**REZONING,
PLANNED UNIT DEVELOPMENT
SIDEWALK WAIVER &
SUBDIVISION STAFF REPORT**

Date: October 18, 2007

Orchard Baptist Church Subdivision

6960 Overlook Road
(Southeast corner of Overlook Road and Howells Ferry Road).

SITE PLAN

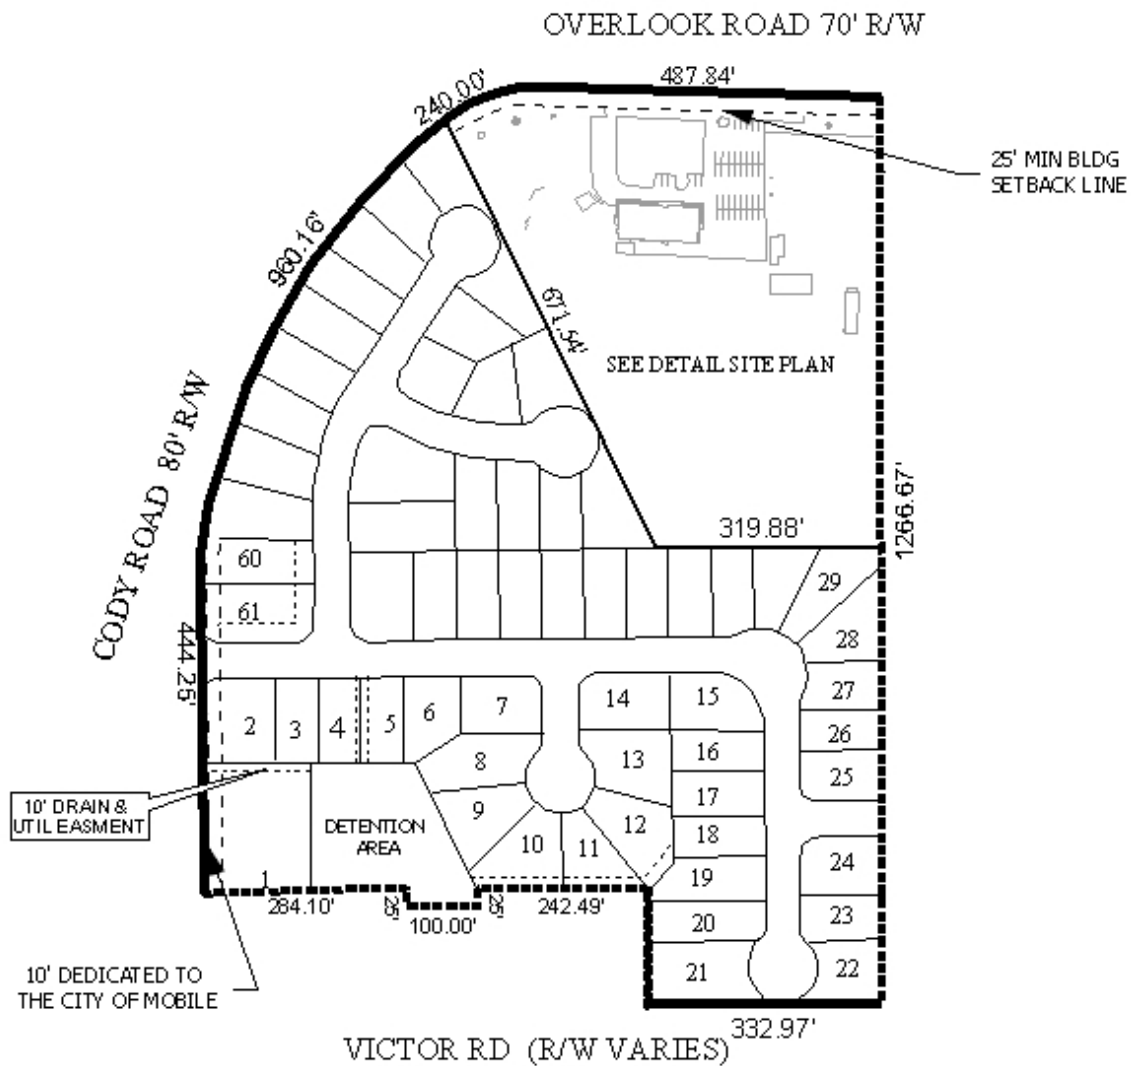
There are several issues with the Rezoning and Planned Unit Development applications as submitted. First and foremost, the site plans submitted do not include any dimensions of improvements. This lack of dimensions makes it virtually impossible to review; and, since these applications are site plan specific, virtually impossible to ensure compliance with the approved plans.

Also, there appear to be some discrepancies between parcel dimensions illustrated on the proposed plat and those of common parcel lines with Overlook Station Subdivision. These discrepancies should be corrected.

The revised site plan illustrates a proposed expansion of parking facilities, which will provide a total of 116 parking spaces on site. The plan indicates that the seating for the church is 500, requiring a minimum of 125 parking spaces. Given the layout of the proposed expansion, it appears that an additional 9 spaces could easily be accommodated in the southern portion of the expanded facilities.

Another issue is that the plan reflects a 320'± continuous curb cut. As shown on the plan, the curb cut would effectively allow direct ingress and egress for 11 parking spaces, and only has an 18-20' wide "formal" entrance into the parking facility. While it appears that this access may be existing, the extensive expansion to the parking facility should be adequate to require modifications to the curb cut and entrances.

While the revised and expanded parking facility provides all required parking on site, there are still buildings owned and occupied by the church on property located across Overlook Road. One of the reasons stated for the prior holdover was the inclusion of that property in the PUD. The applicant did not include that property, and provided no information as to why it was not included. Inclusion of those properties is necessary to "tie" the properties together should there be a future separation and to ensure adequate parking and access are provided for both sites. This may also necessitate a subdivision application for those properties located across Overlook Road.

1. correction/depiction of dimensions along the South and East property lines, to coincide with those from Overlook Station Subdivision;
2. placement of a note on the final plat stating that the site is limited to a maximum of three, 24' wide curb cuts, size, size, location, and design to be approved by Traffic Engineering and conform to AASHTO standards;
3. removal of extraneous paving materials from the continuous curb cut and installation of landscape material, to coincide with redesigned and approved 24' wide curb cuts.

1. the site is limited to a maximum of three, 24' wide curb cuts, size, size, location, and design to be approved by Traffic Engineering and conform to AASHTO standards;
2. removal of extraneous paving materials from the continuous curb cut and installation of landscape material, to coincide with redesigned and approved 24' wide curb cuts;
3. completion of the subdivision process prior to the issuance of any permits;
4. development limited to an approved PUD; and
5. full compliance with all municipal codes and ordinances.

Planned Unit Development: Based upon the preceding, this application is recommended for HOLDOVER until the December 20 meeting to allow the applicant to revise the plan to include all properties associated with the church and used for church functions (parking, services, classrooms, etc), and illustrate revisions to parking facilities as referenced in the remarks section of this report.
